STATE OF RHODE ISLAND AND PROVIDENCE PLANTATION
DEPARTMENT OF TRANSPORTATION
RHODE ISLAND CONTRACT NO.2011-CT-109
FEDERAL-AID PROJECT NO. FAP Nos: HPP-0974(004)

Division Street Access Improvements EARMARK funds. Design funded by NE Tech/Construction by RIDOT

NOTICE TO PROSPECTIVE BIDDERS

ADDENDUM NO. 1 Prospective bidders and all concerned are hereby notified of the following changes in the Plans, Specifications, Proposal and Distribution of Quantities for this contract. These changes shall be incorporated in the Plans, Specifications, Proposal and Distribution of Quantities, and shall become an integral part of the Contract Documents.

CONCRETE PAVER APRON IN SPLITTER ISLAND WITHOUT PLANTING
 NOT TO SCALE

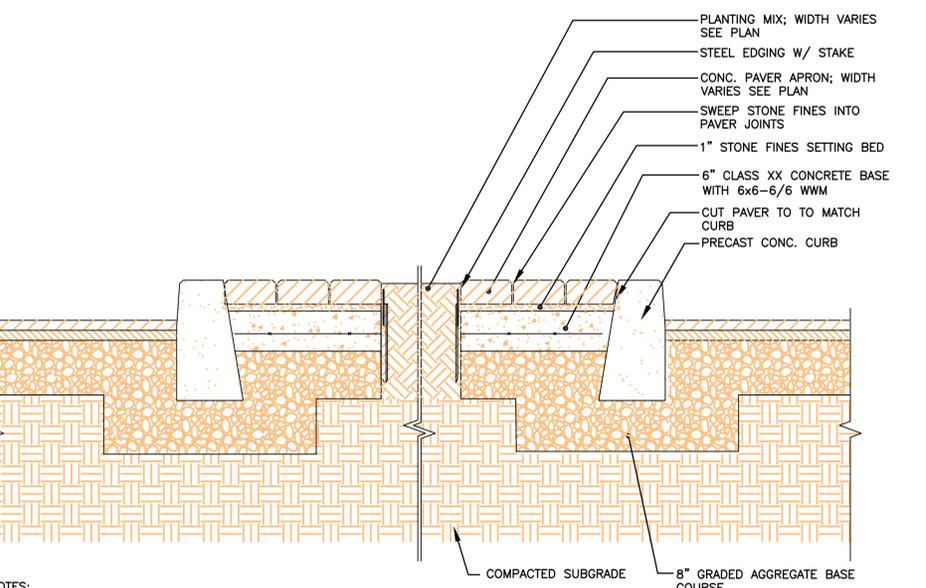
3. Sheet 22 - Miscellaneous Details Sheet No. 1

Remove Sheet 22 in its entirety and replace it with revised Sheet 22(R-1) attached to this Addendum No. 1. The "Sediment Forebay Outlet Weir Detail" and the "Cross-Section Detail for Brick Paver Crosswalk (BPC)" have been revised and three (3) details have been added, "Typical Section of Rip-Rap", "Concrete Paver Apron in Splitter Island without Plantings" and "Concrete Paver Apron in Splitter Island with Plantings."
